DESCRIPTIVE REPORT

Registry No. **H-11200**

General Locality **Approaches to Prince William Sound**

Revisions Compiled During Office Processing and Certification

Figure 1 H11200 Survey Limits

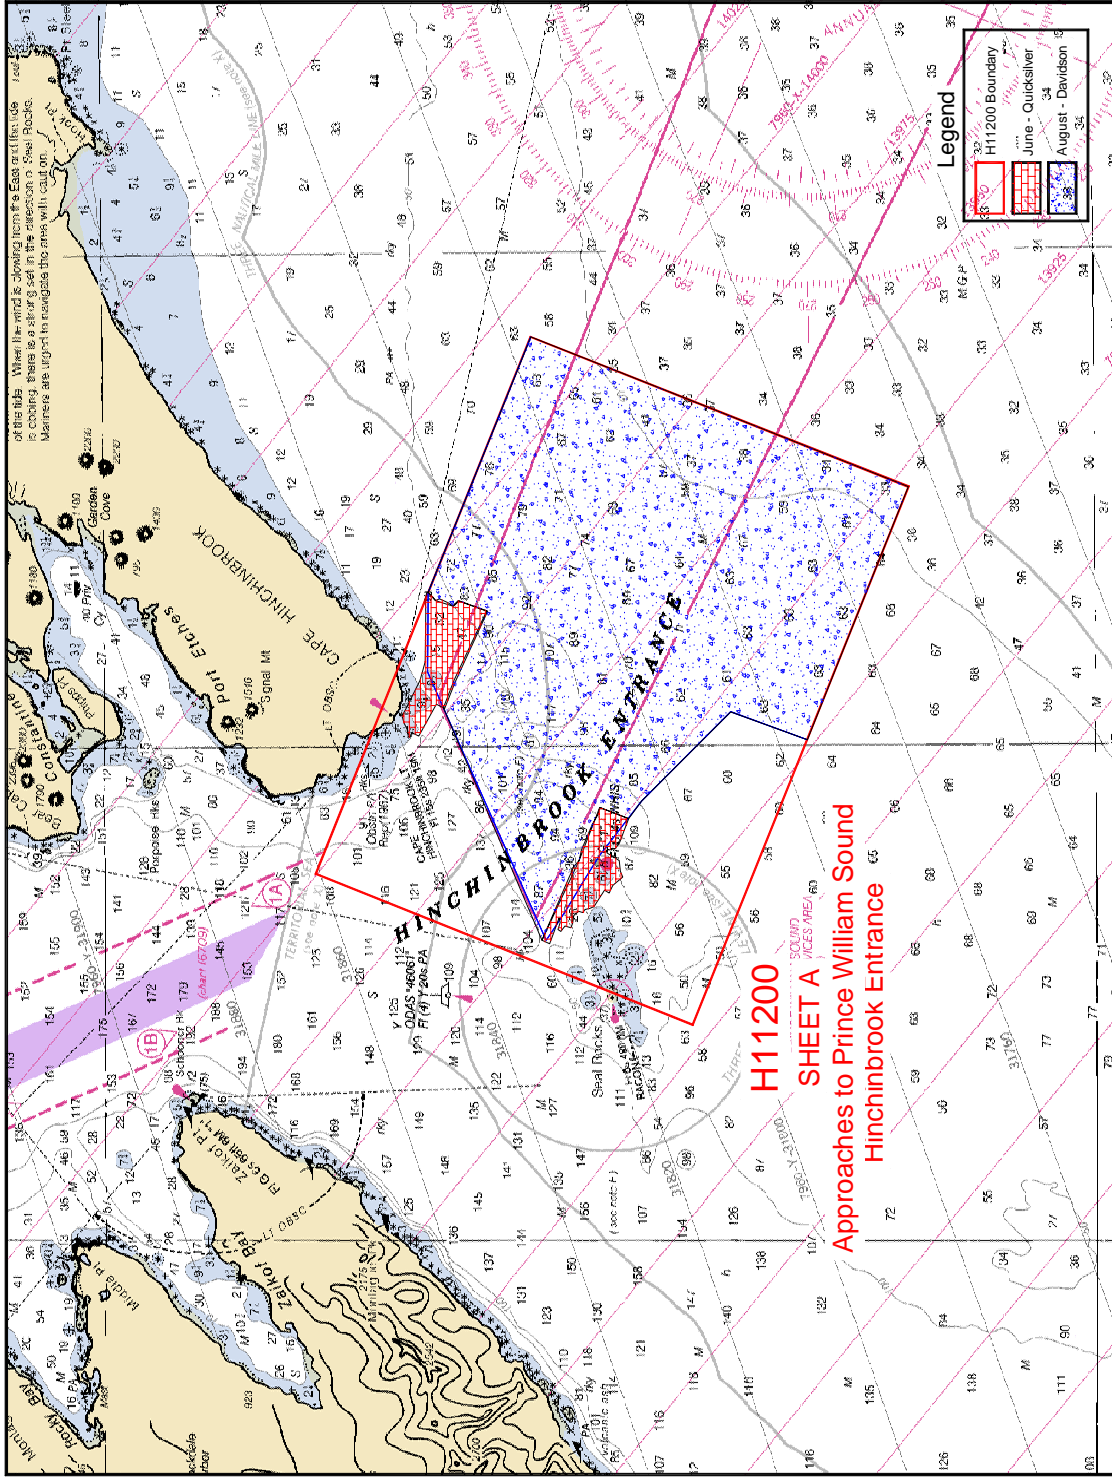
Table 1 H11200 Survey Limits¹

¹ Revise sheet limits to the following:

60/13/59N, 146/38/47W

60/11/49N, 146/24/48W

60/04/46N, 146/30/27W

60/11/03N, 146/48/00W

Figure 5 Sample SVP Plot

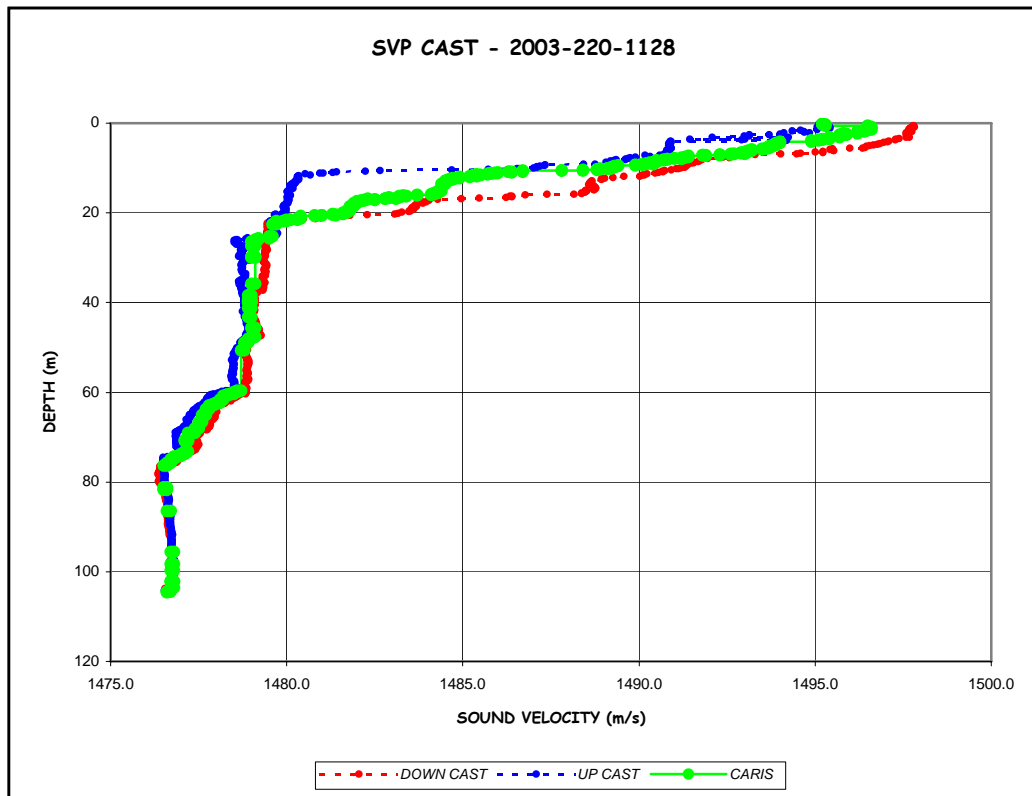
- During data acquisition and routine processing, a general downward and/or upward cupping was noticed in the across track sounding profiles for certain areas. This is possibly due to the high volume of thermal layering and strong under currents in the water column, an example of this can be seen in the figure below. In an attempt to resolve this cupping, SVP casts were conducted more frequently and line spacing reduced. (Refer to Separate 2 for SVP plots).³

³ Concur.

Figure 6 H11200 Survey Junctions

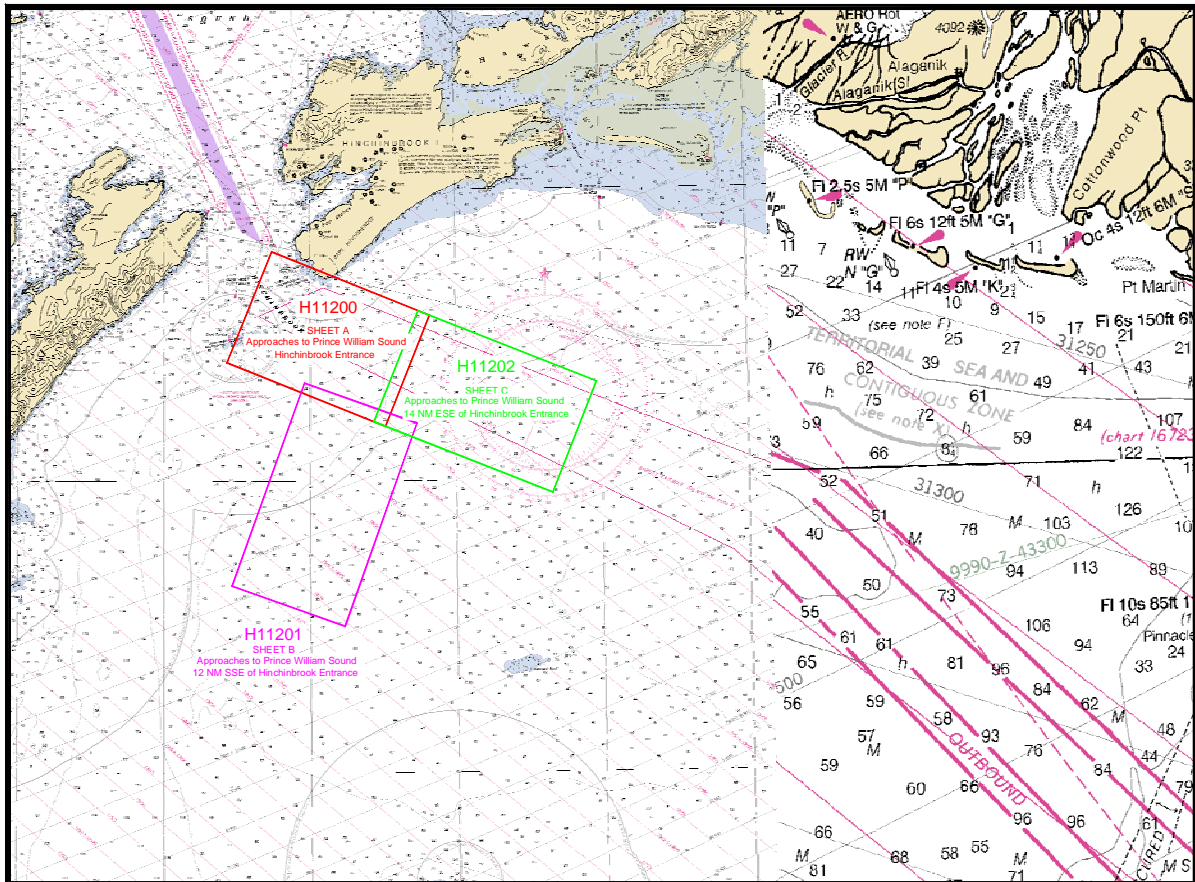
Registry #	Scale	Date	Junction Side
H11201	1:20,000	2003	NNE ⁴
H11202	1:20,000	2003	WNW ⁵

⁴ PHB Revision--Strikethrough ~~NNE~~ and insert SSW.

⁵ PHB Revision--Strikethrough ~~WNW~~ and insert ESE.

Figure 9 Comparison of Contours

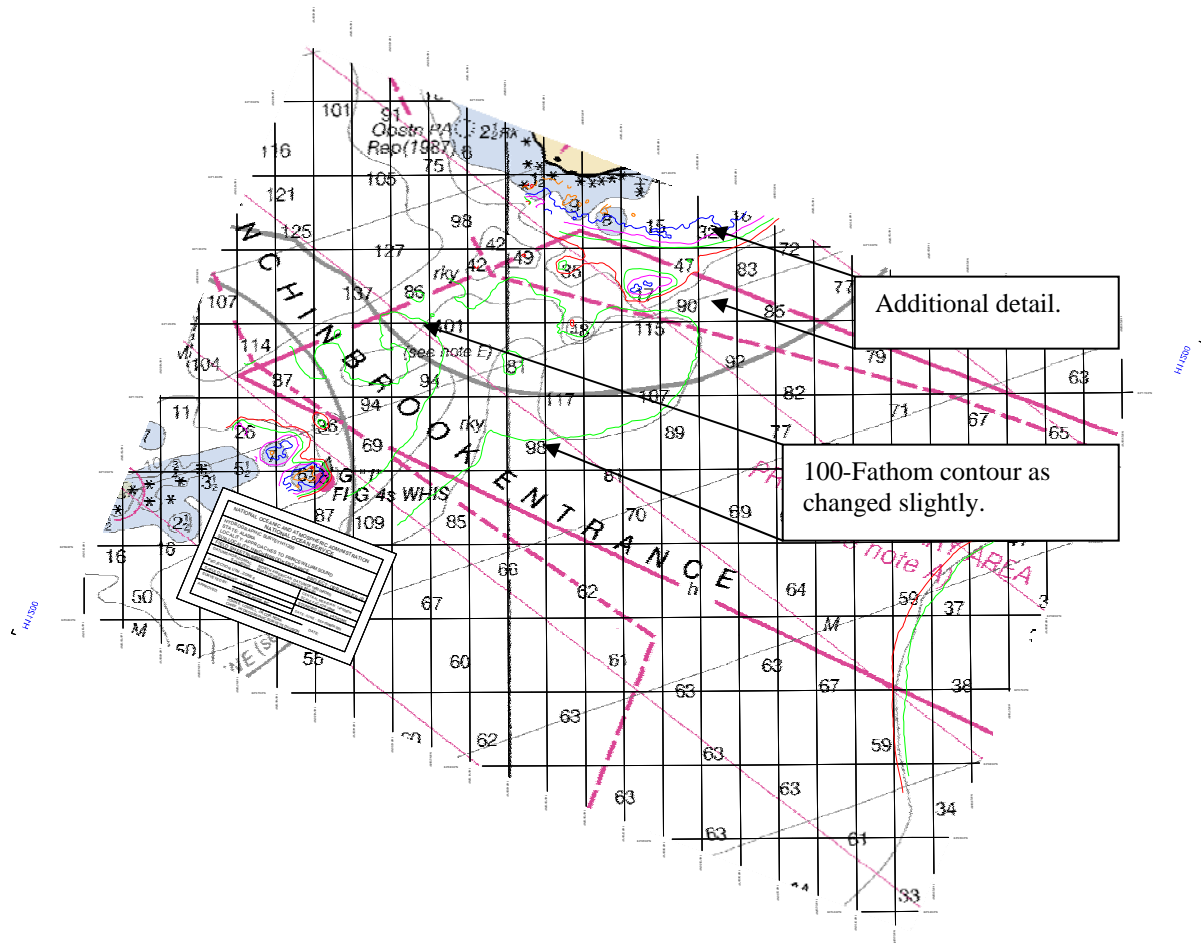
H11200 contours show more detail in the bottom topology in the offshore region, but compare well with the existing charted contours.¹⁰

¹⁰ Concur.
